DESIGN REVIEW COMMITTEE

June 4, 2015

STAFF REPORT AND FINDINGS OF FACT

SUBJECT: Design Review Request (DR15-03) by Wesley Houck for Steven and Cheryl Mazzuca to construct a single-family dwelling at 275 29th Street

North Elevation

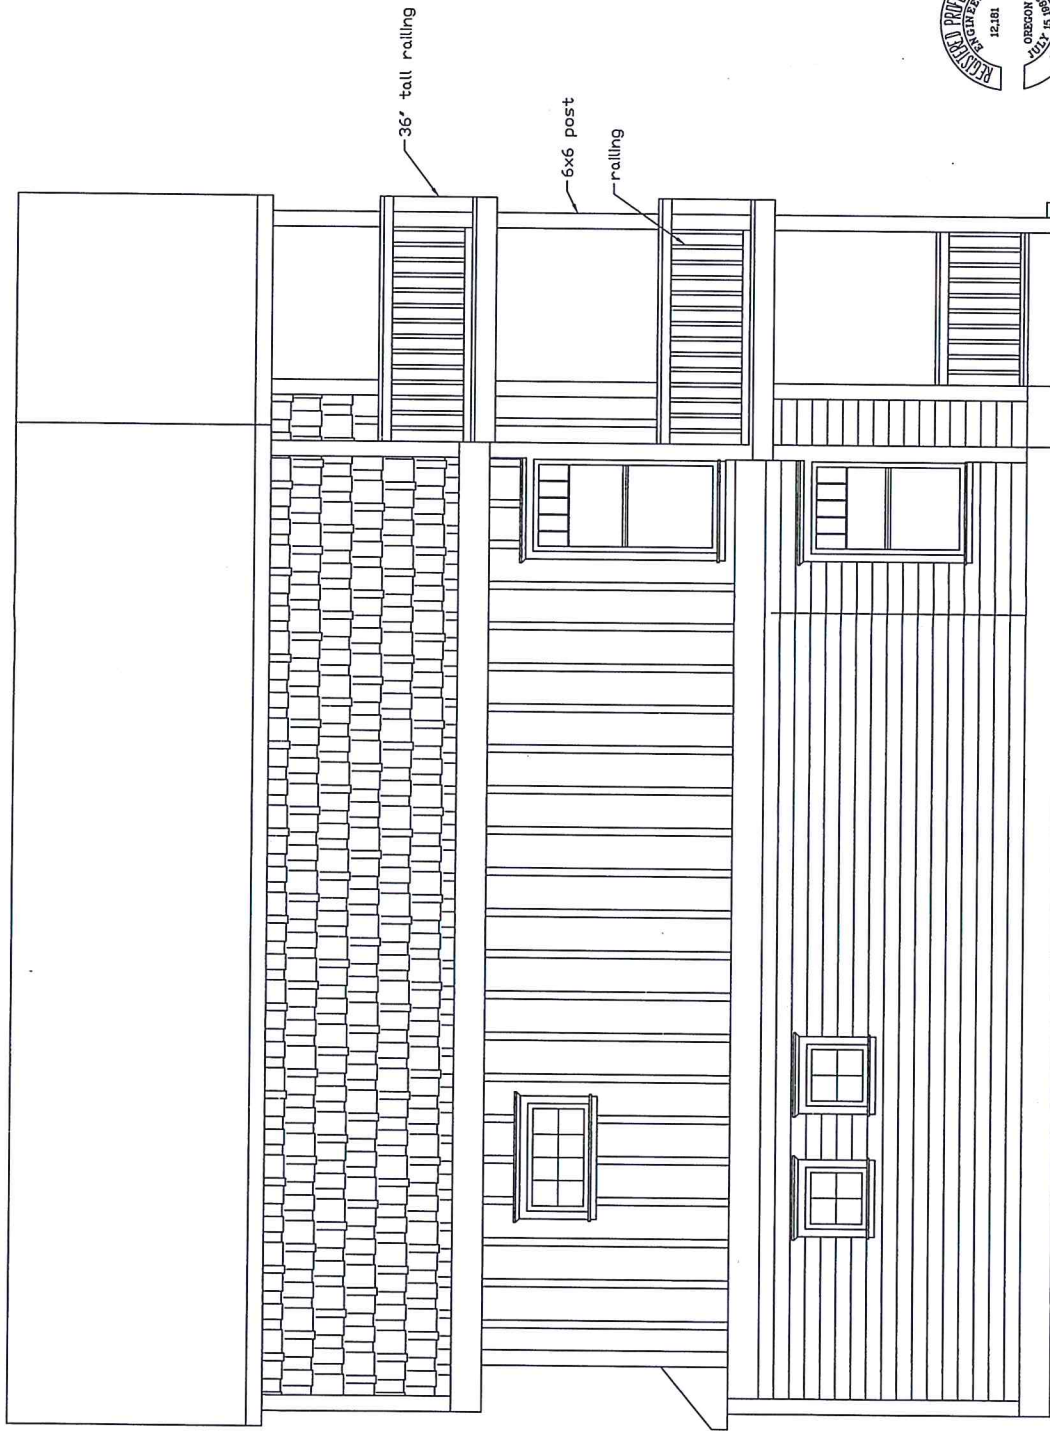
Finding: Exterior light fixtures are proposed only on the rear on either side of the garage door. It must be downcast and subdued. This guideline is met.

1. There shall be no encroachments into the required 6' side setback.
2. Windows and casings shall be installed so that the windows do not protrude beyond the casing; and so that the casing protrudes beyond the plane of the siding. Any windows with grids shall be true divided or shall have external grids.
3. Exterior light fixtures shall have diffused and downcast lighting.
